SUBJECT: Forwards response to NUREG-0619 re feedwater nozzle & control rod drive return line nozzle cracking, completing action on SER Outstanding Issue 20.

SUSQUEHANNA STEAM ELECTRIC STATION  
SER OUTSTANDING ISSUE NO. 20  
ER 100450                      FILE 841-2  
PLA-807

PP&L RESPONSE TO NUREG-0619

BWR FEEDWATER NOZZLE AND CRDRL NOZZLE CRACKING

Figure 1. Three Feedpump Plant Configuration with GE proposed new low flow control design

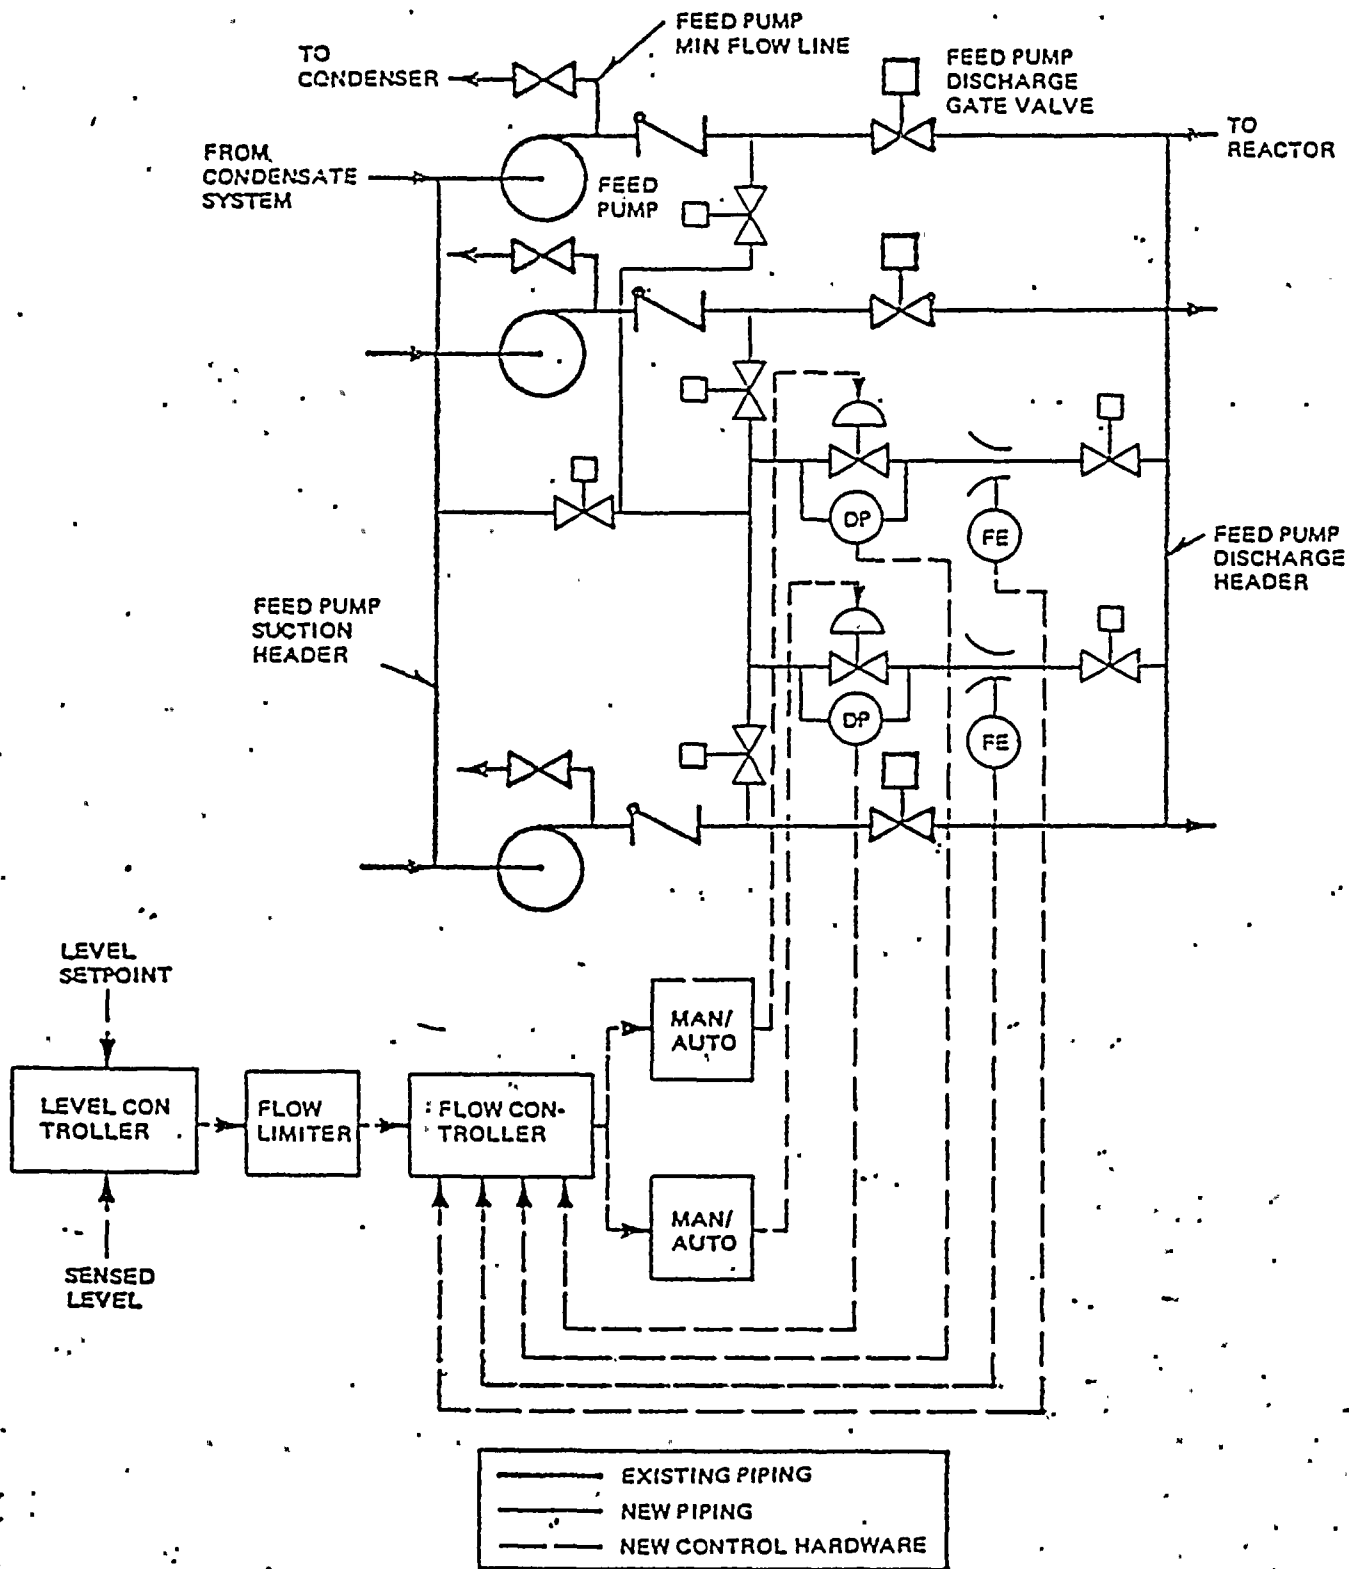
Figure 1 represents the GE proposed new low flow control design as applied to a feedwater delivery system configuration. Figure 2 represents the existing low flow control system (supplied by GE) as installed at Susquehanna plant.

PP&L, after evaluating the options, will implement either Item B.1.a or Item B.1.b above to meet the intent of NUREG-0619, since both are acceptable to NRC.
